Office Action Summary	Application No. 10/791,607	Applicant(s) LAI ET AL.	
	Examiner Toniae M. Thomas	Art Unit 2822

DETAILED ACTION

8. *Claims 22, 24-25, 34 and 36 are rejected under 35 U.S.C. 102(b) as being anticipated by Moore (US 2003/0038301 A1).*

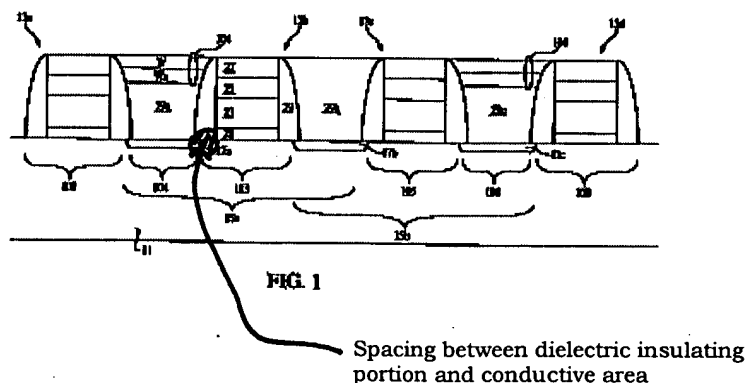
The Moore application publication (referred to hereinafter as Moore) discloses a phase change memory structure (figs. 1-6 and accompanying text). The phase change memory structure comprises: a substrate 11 (fig. 1 and par. 0016, lines 1-2) comprising a conductive area, source/drain region 17a (fig. 1 and par. 0016, lines 7-9); a spacer 29 having a partially exposed sidewall region at the spacer upper portion defining a phase change memory element contact area (fig. 1 and par. 0016, lines 13-14); wherein the spacer bottom portion partially overlaps the conductive area (fig. 1).

As shown in the illustration below, the spacer 29 has a sidewall portion that is partially exposed by the polysilicon plug 29a.

The spacer is disposed adjacent a sidewall of a dielectric insulating portion, capping insulator 27 (fig. 1 and par. 0016, lines 9-14).

The dielectric insulating portion is disposed spaced apart from the conductive area (fig. 1).
